Transport Response

Dover Road, Walmer, Kent

Iceni Projects Limited on behalf
of Gladman Developments

1. RESPONSE TO 13TH JULY 2017 HIGHWAY COMMENTS

A5. ADDITIONAL FLOW DIAGRAMS

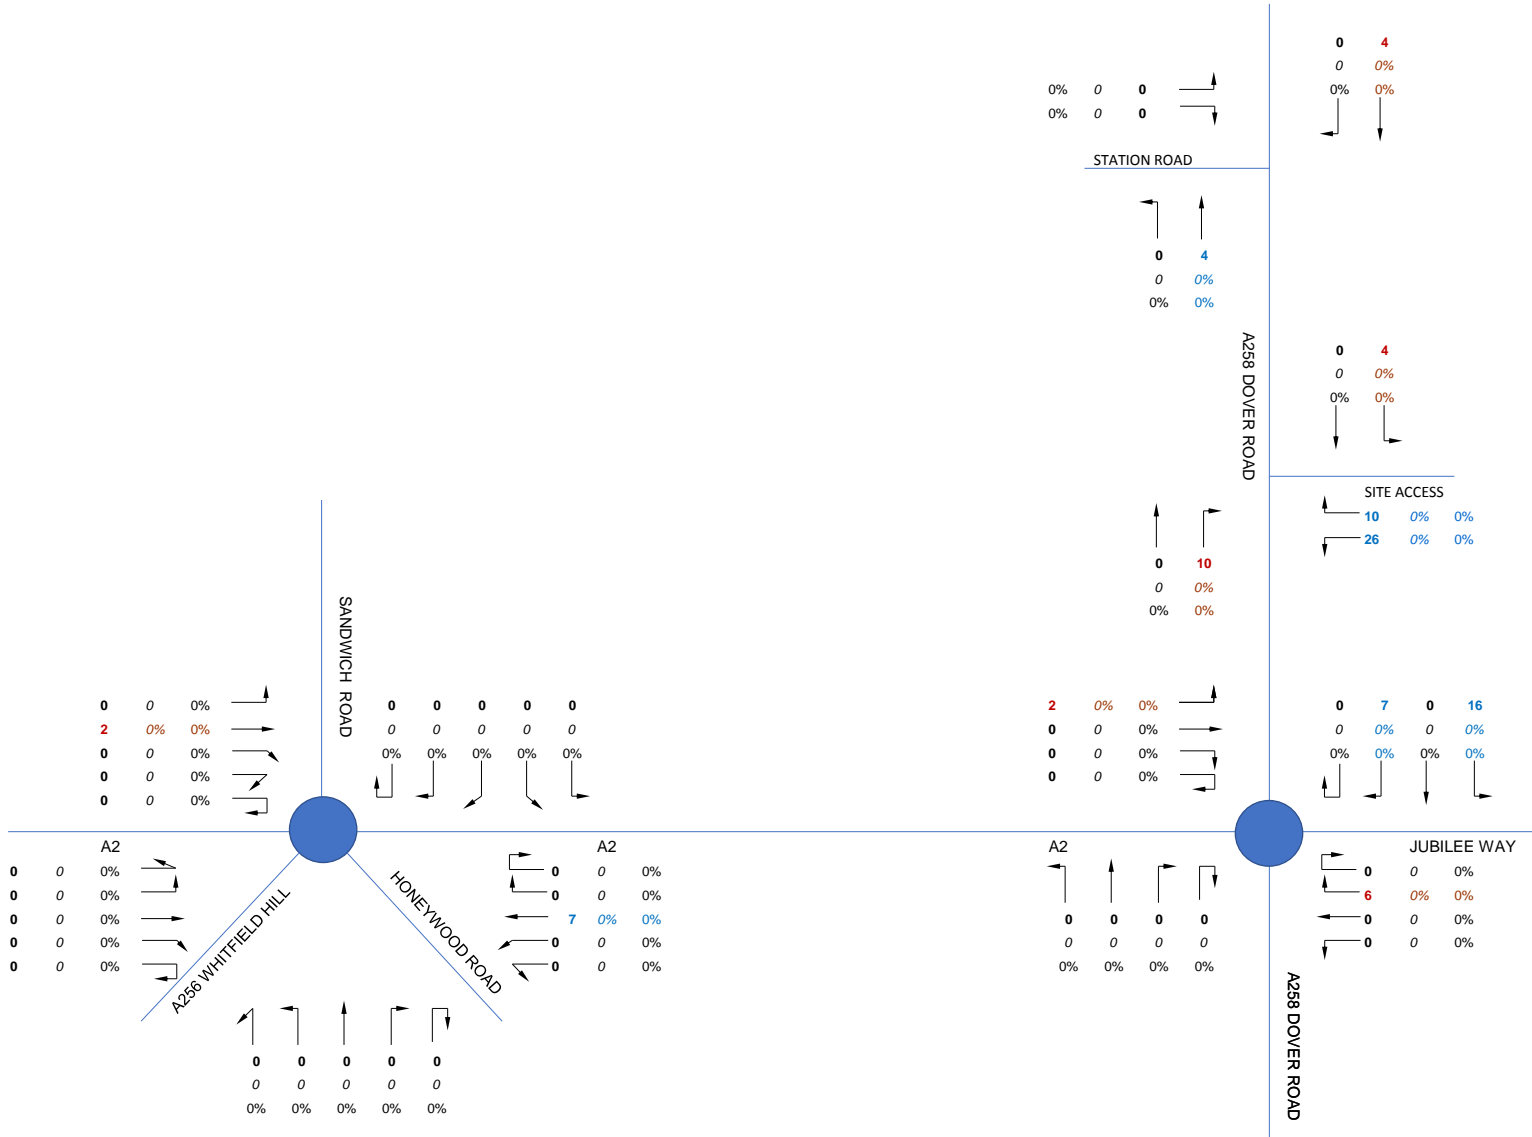
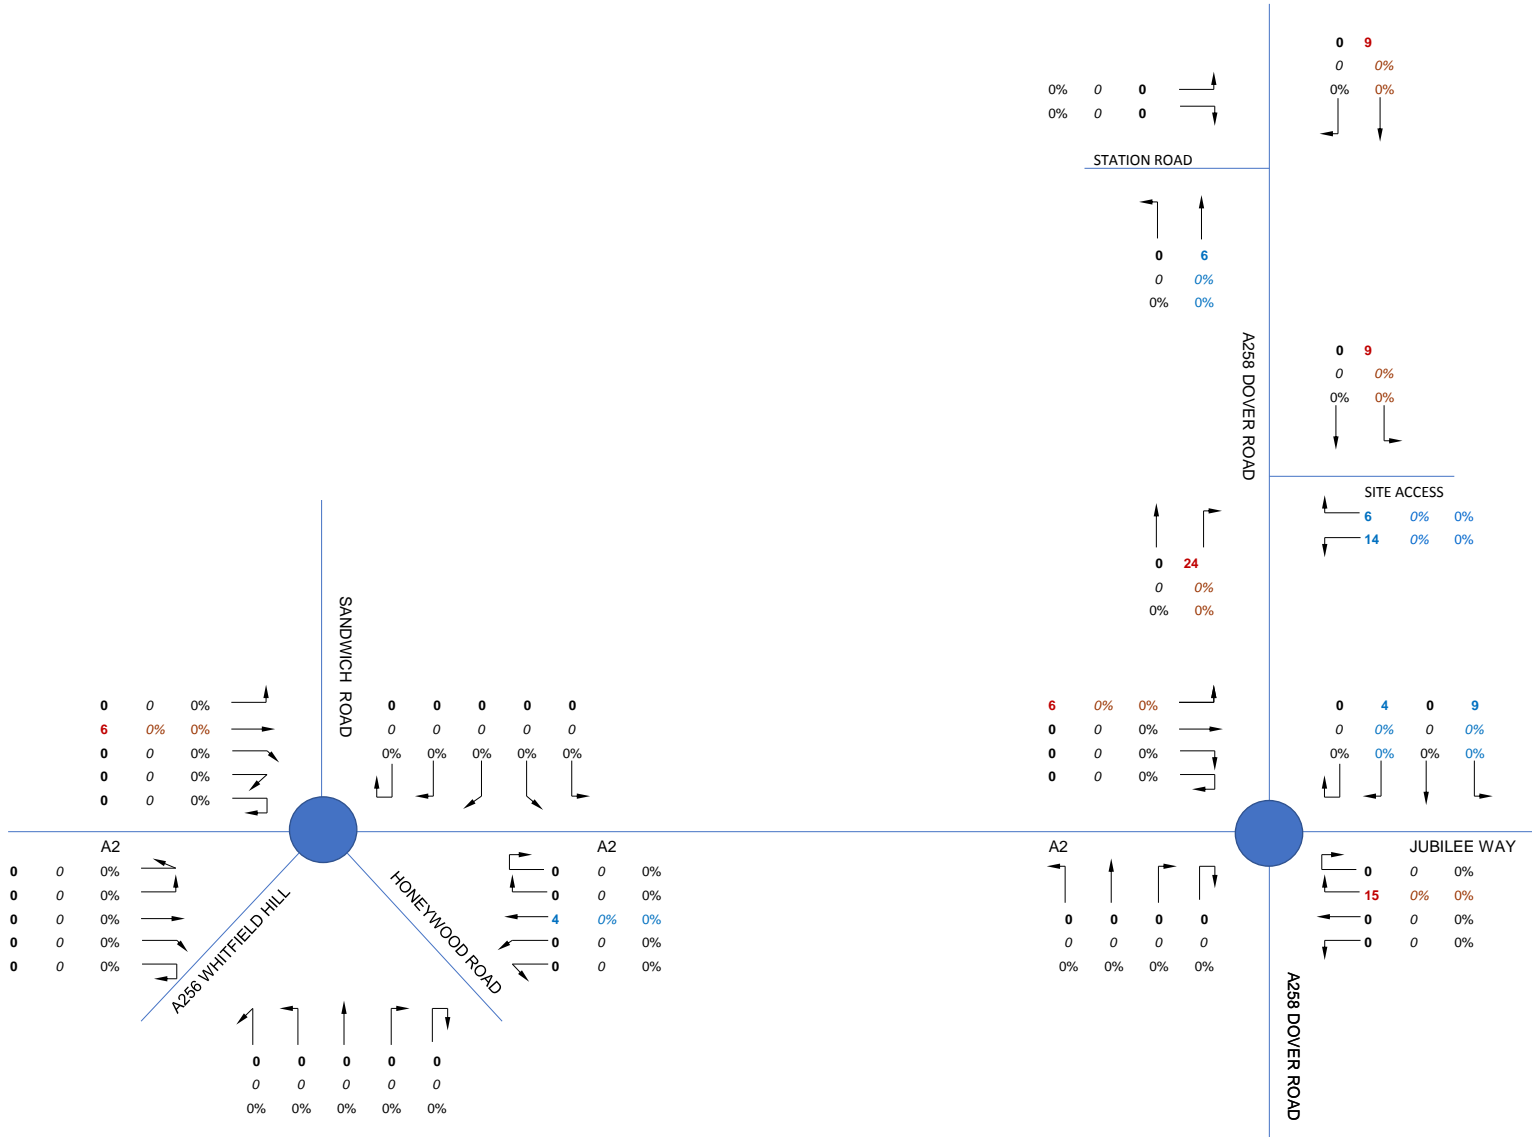
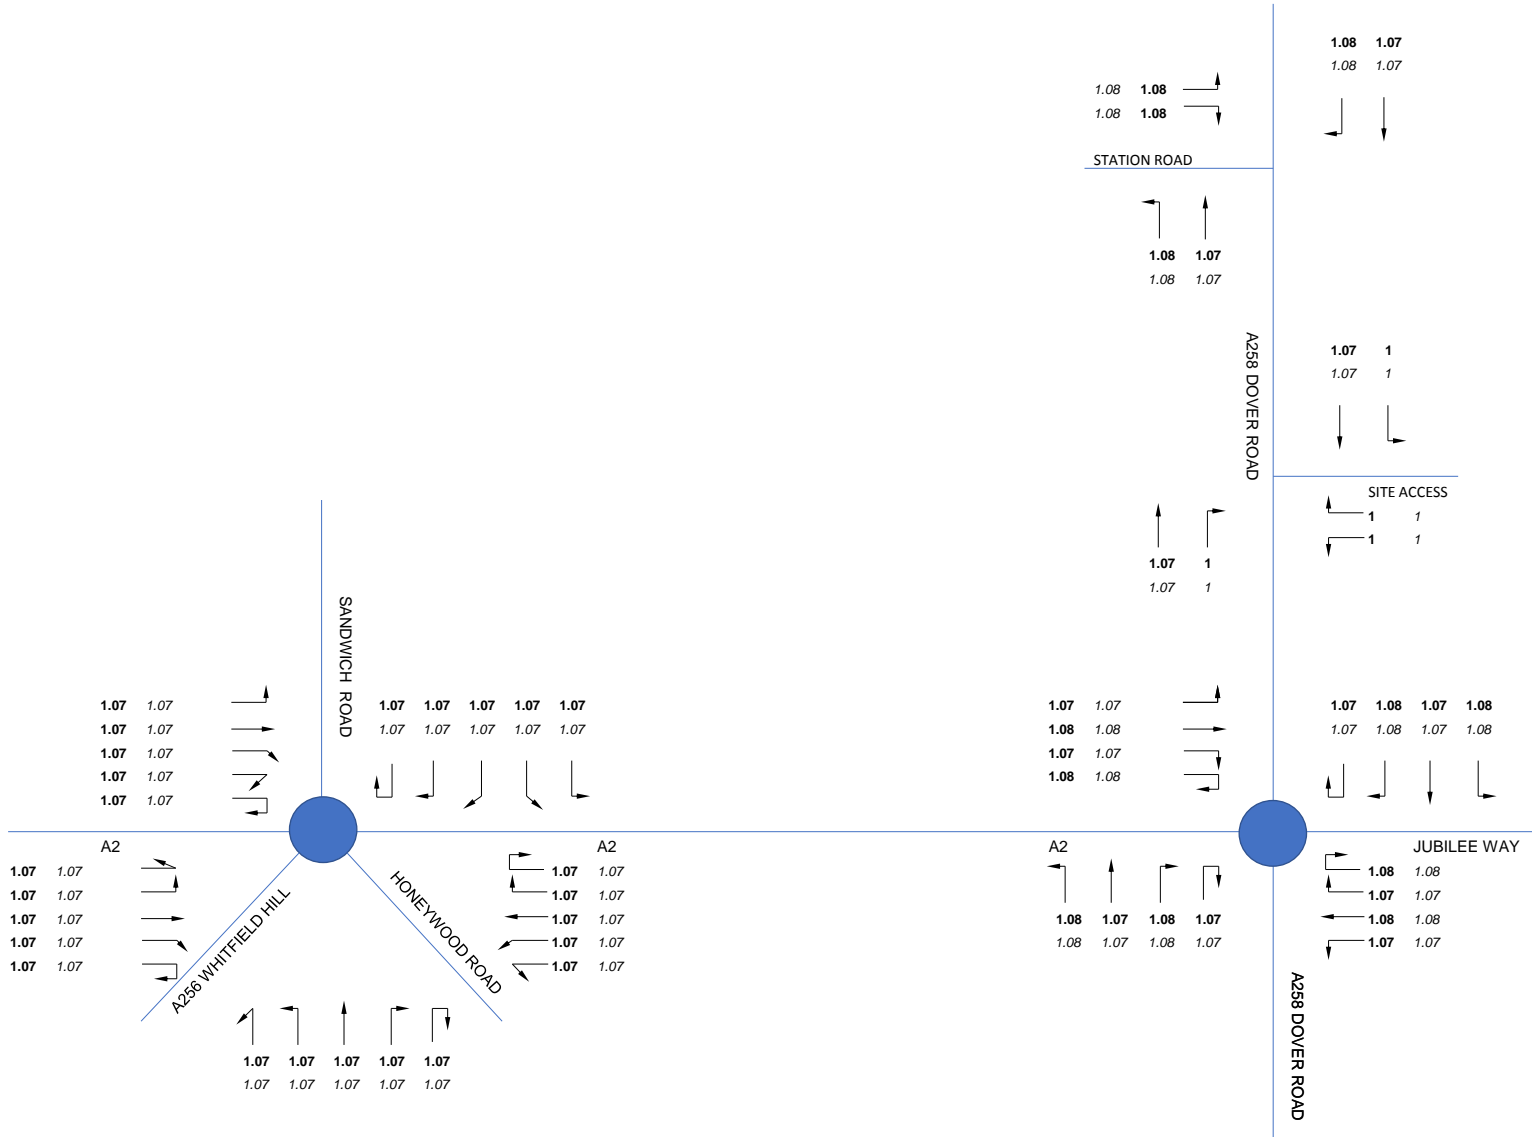
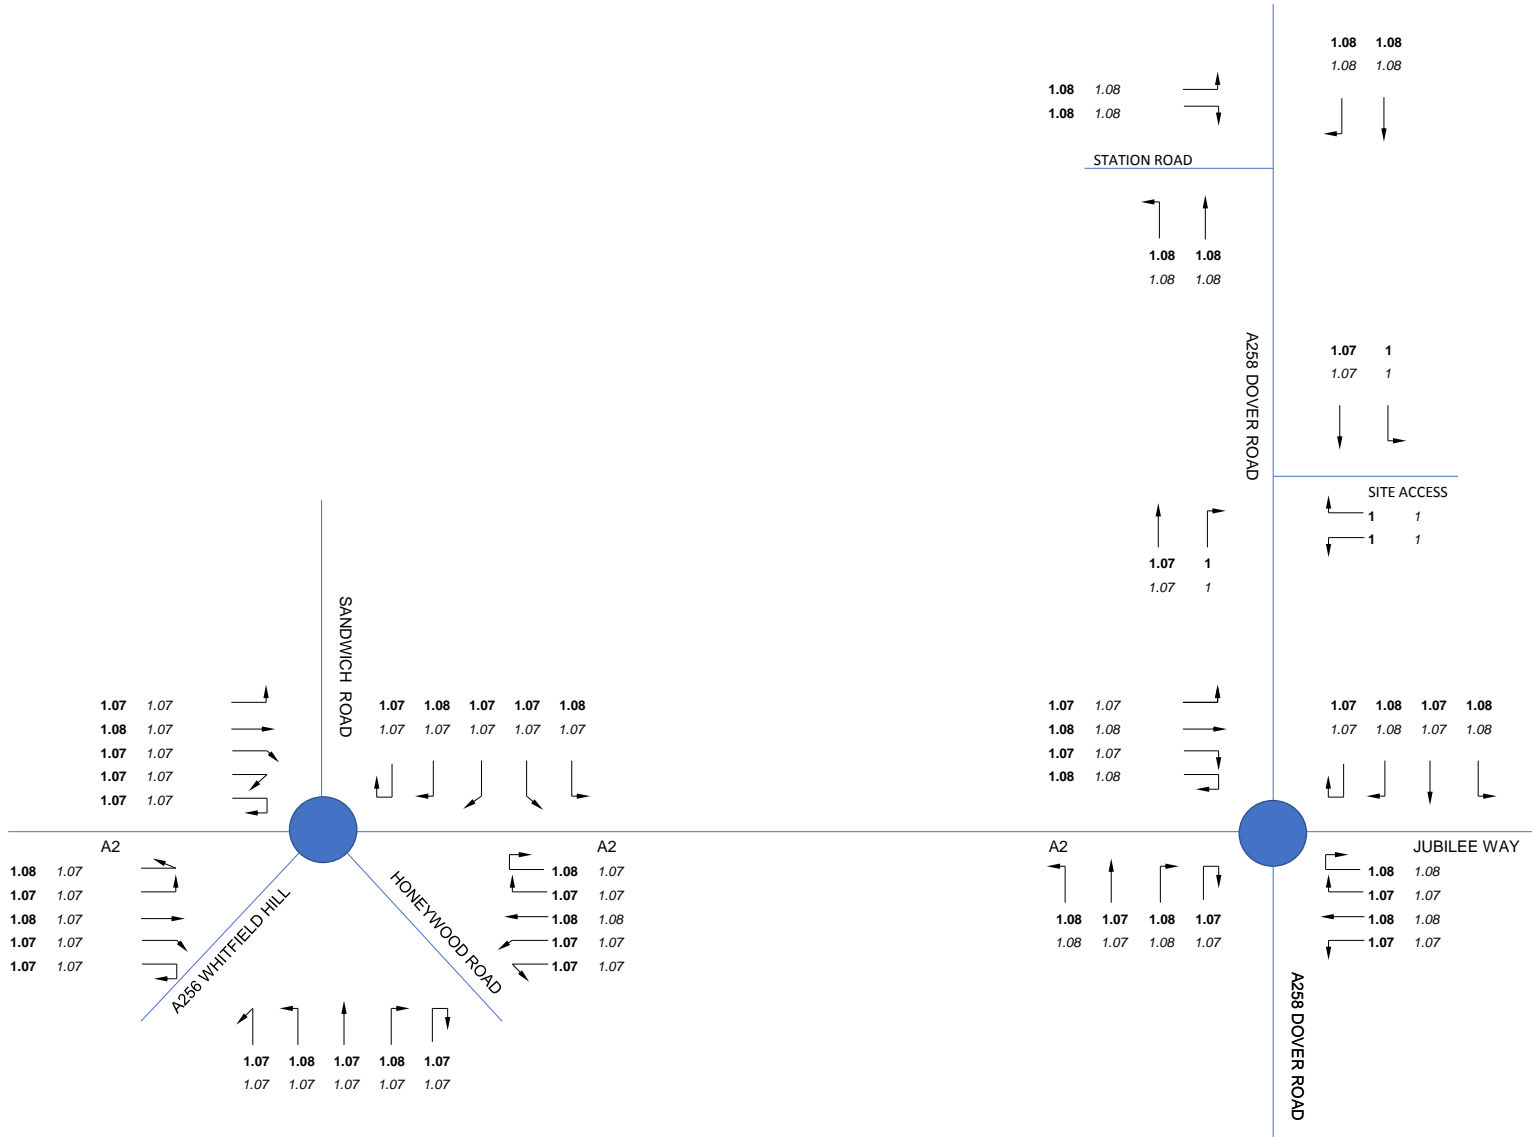
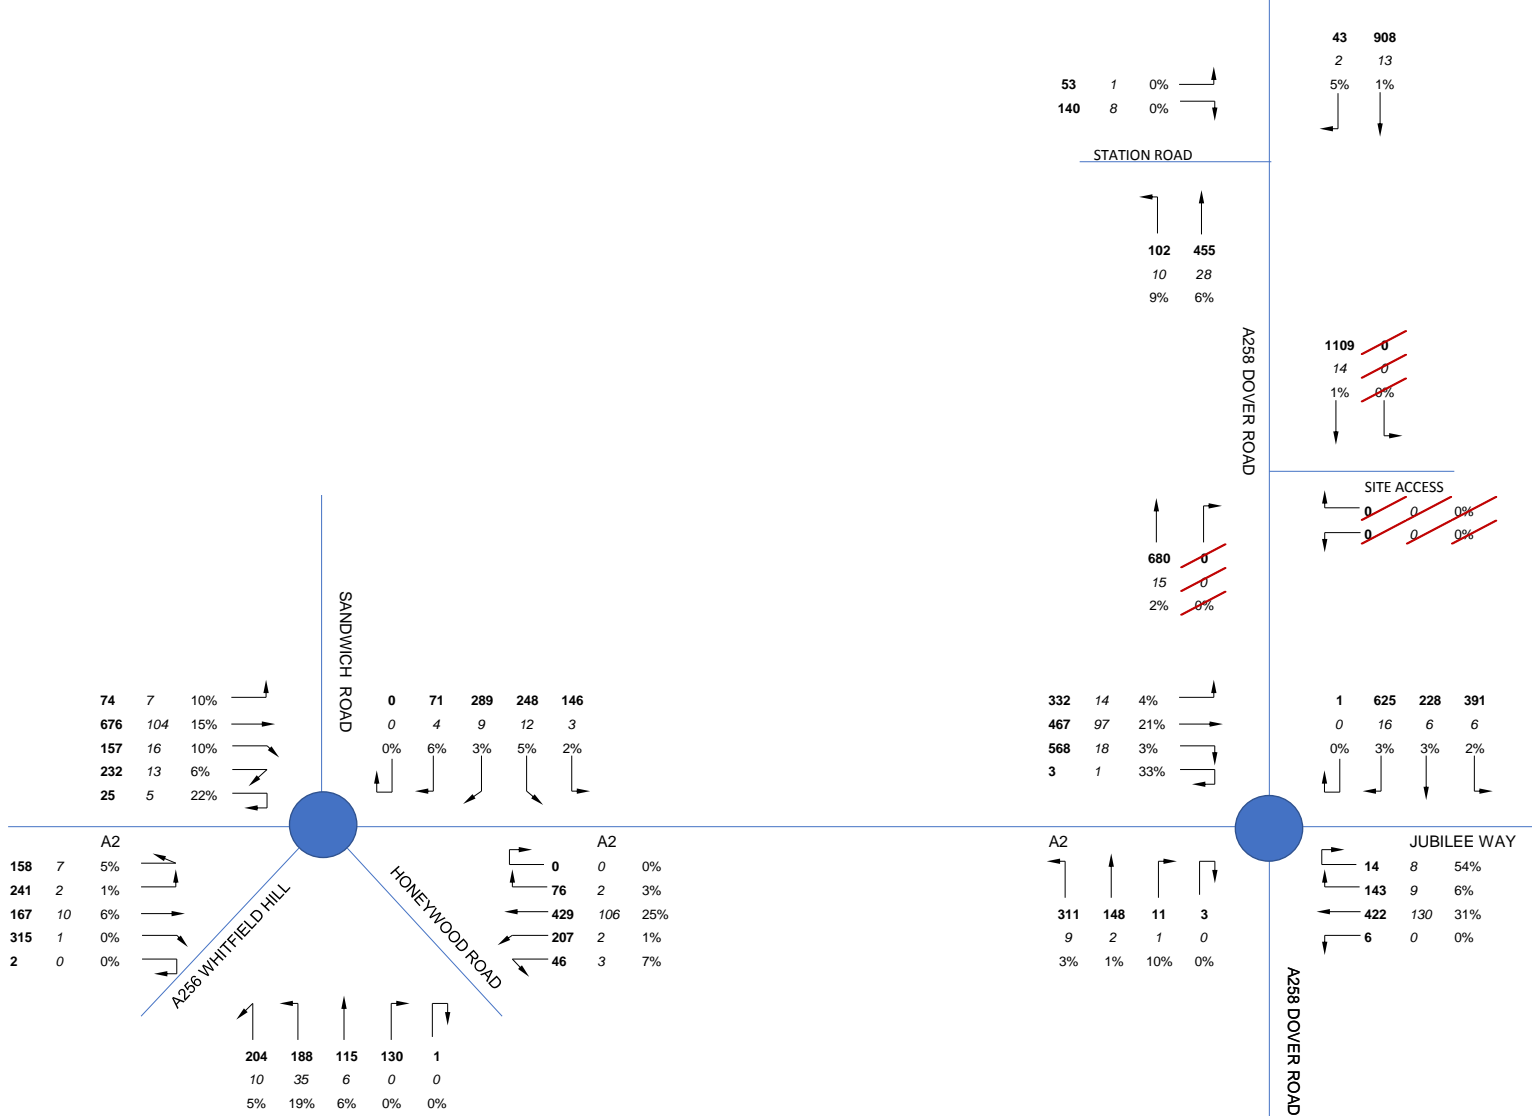
It is not clear how the 2022 base and 2022 development figures have been derived. I wish to see additional flow diagrams giving a breakdown of the TEMPRO, committed development and proposed development trips added.

- 1.9 This data is provided with this note at **Appendix A5**.
